June 16, 2015

Nick Gioello, Planner
City of Eugene
Planning and Development Department
99 W. 10th Ave.
Eugene, OR 97401
<mailto:nick.r.gioello@ci.eugene.or.us>

AT&T hereby submits the attached 5 additional exhibits for submittal to the record. I anticipate one additional exhibit for submittal before the close of business on June 17, 2015.

SHEET NUMBER
 A-1

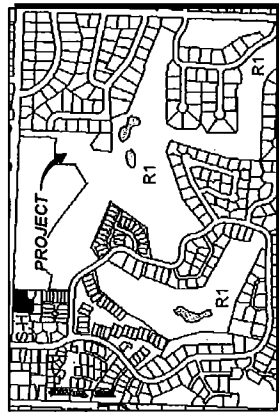
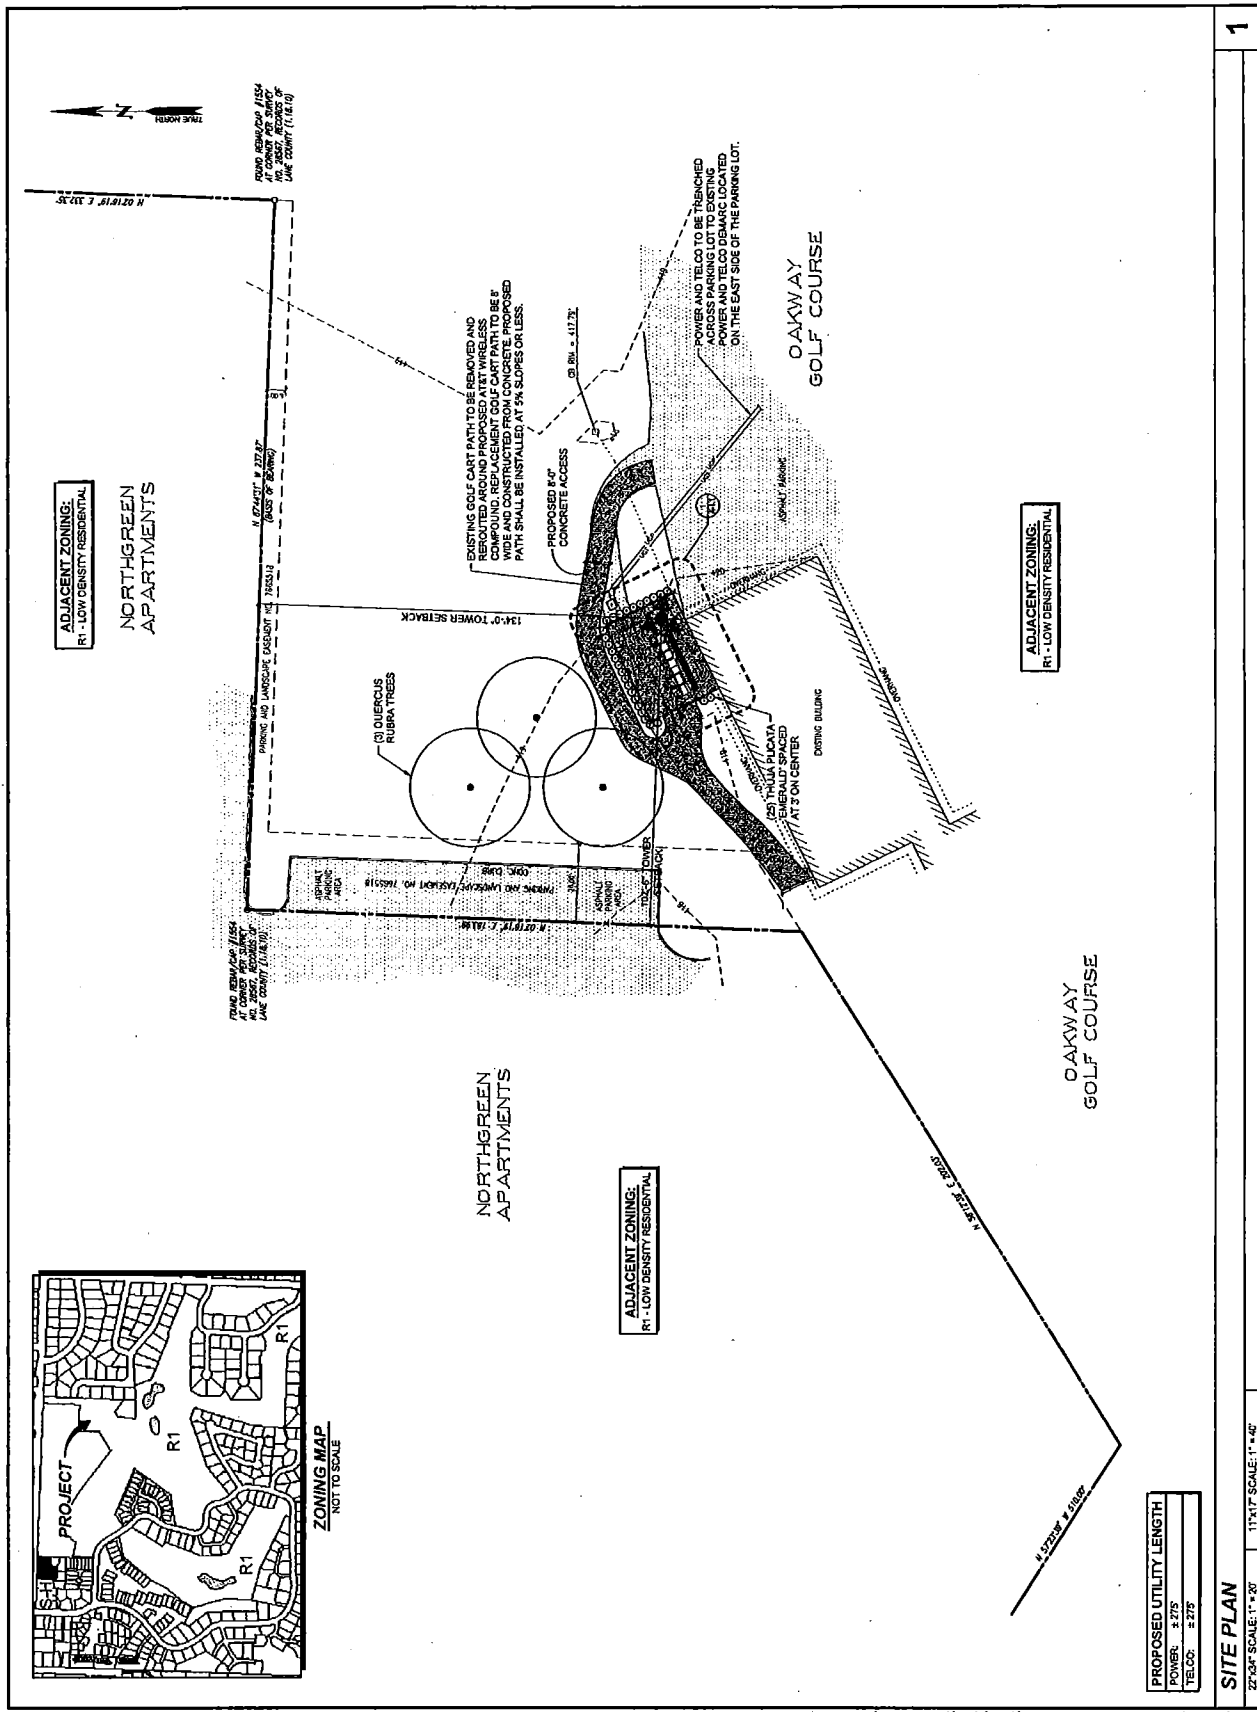
As shown on the applicant's site plans (Sheet A-1) the tower is setback 102'-6" from the nearest property line, in compliance with this standard.

Prior to final PUD approval, Sheet A-1 shall be revised to include the following note. "If lighting is required by the FAA no high intensity white lights may be located on the tower."

Prior to final PUD approval, Sheet A-1 shall be revised to include the following note. "The transmission tower and attached antennas shall be unpainted galvanized steel or painted neutral colors or shades with a matte finish as approved by the city."

7. Prior to final PUD approval, Sheet A-1 shall be revised to include the following note. “If lighting is required by the FAA no high intensity white lights may be located on the tower.”

8. Prior to final PUD approval, Sheet A-1 shall be revised to include the following note. “The transmission tower and attached antennas shall be unpainted galvanized steel or painted neutral colors or shades with a matte finish as approved by the city.”
